# UNITED STATES PATENT AND TRADEMARK OFFICE

APPLICATION NO.	FILING DATE	FIRST NAMED INVENTOR	ATTORNEY DOCKET NO.	CONFIRMATION NO.
10/780,401	02/16/2004	J. Mark Morrow	031599/260283	1618

**Office Action Summary**

FIG. 5.

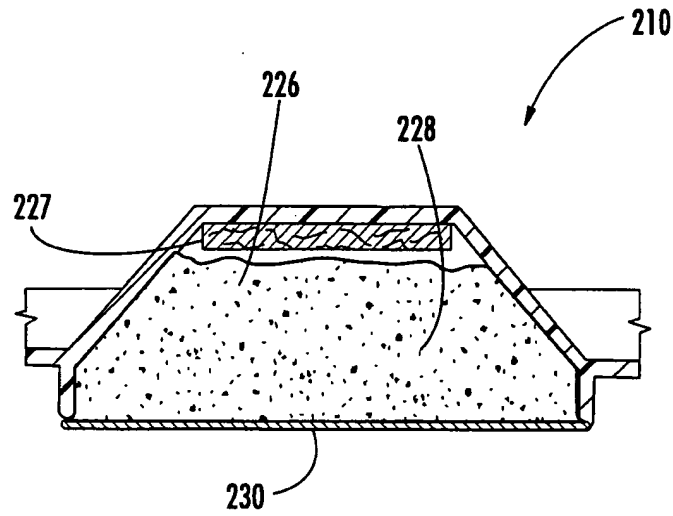
1. The new drawing (Figure 5) was received on 2/13/2006. This drawing is approved by the Examiner.

OK. To ENTER. LRB  
3/31/06
